Critique for Design Task 6

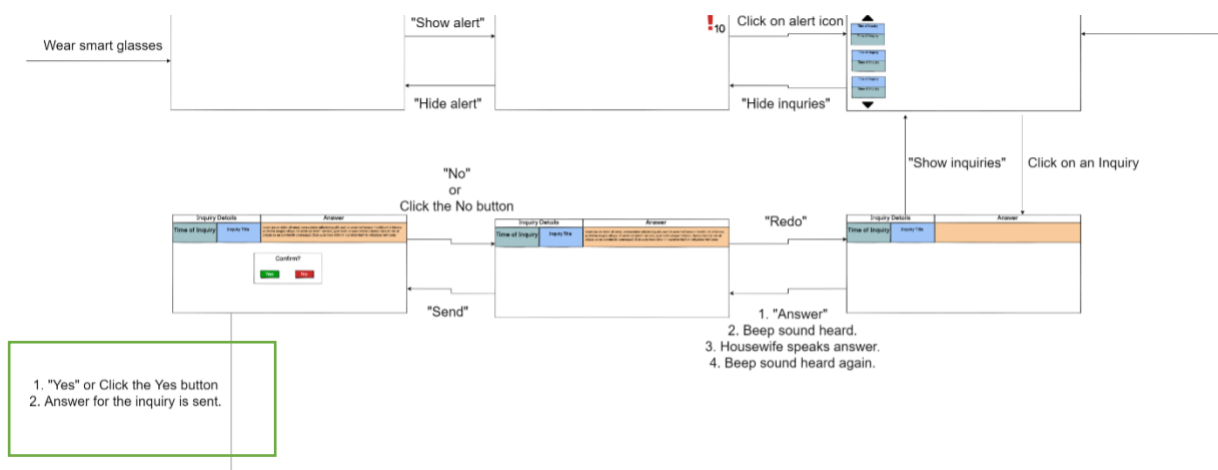
I found the wireframe workflow to be straightforward, however I am not sure if the design of the interface screen shown in the flow is spanning across both or just one of the lens.

It seemed that the smart glasses is heavily dependent on speech commands instead of using the ring mouse. I see that the speech commands are used to address User Needs #2.

However, this of concern to me because as mentioned in the question, speech recognition has an error rate of around 5%. This mean that user's speech command can be misinterpreted or not understood by the smart glasses occasionally. Hence, you might want to consider adding a recovery mechanism either via speech and/or the ring mouse during the Figma prototyping stage.

I would like to bring attention to the boxed up area as well. It seemed that after user sends a message, the smart glasses automatically returns to the Inquiry screen with no indication of whether the message has being sent successfully. In a regular messaging application, there will always be a clear indication of whether messages have been sent successfully which assures users. Hence, as a user of the smart glasses, I could feel uneasy without such an indication especially since it is concerning my business.

I see that you have changed the icon for unread inquiries from the chat icon in the sketches to an alert icon in the wireframe, an alert icon may not be applicable since it is not used to represent anything urgent or of particular importance. I would think that a chat icon is more

relatable and applicable. The term Answer has been used to indicate user's reply. While it does not confuse me, terms such as reply or your message might be better as they have a clearer meaning to it.

You have chosen to use the Inquiry screen with inquiries displayed on the far left instead of placing it at the top and that is really good, displaying the inquiries at the side is similar to how messaging applications display messages which is a layout more familiar to users.

Lastly, on the Answer screen, it is unnatural to me that the Inquiry and the Answer sections are displayed side by side. This might be an attempt to address User Needs #3 where the empty space at the bottom of the glasses allow users to look their surroundings. You might want to consider how the Inquiry screen can look like spanning across both lenses.
